SERVICE BULLETIN

IMPORTANCE	HIGH
AREA AFFECTED	PITOT TUBE
SA/B NUMBER	CH 014 10 2020
EFFECTIVE DATE	21 OCTOBER 2020

Inspection of the pitot tube to determine if pitot static ports are or are not present.

Figure 3: Section and broken view of drawing showing static port locations (endcaps not shown)

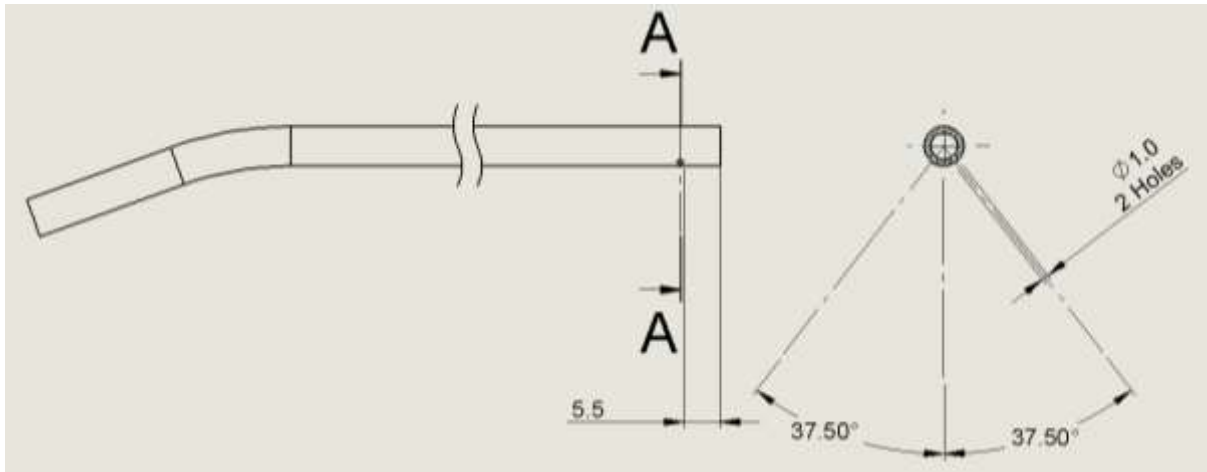
1. All aircraft pitot tubes must be inspected visually before further flight and it must be determined whether the tubes have static ports or not. See the following figures to describe where the 2 ports may be found. Note that they are small, so care must be taken to look in a well-lit area, and closeup. If ports are present, the aircraft can be flown as normal without any further need for action.
2. If the static port holes are not found, no further flight must be performed on the aircraft, and the factory/distributor must be contacted and informed immediately.
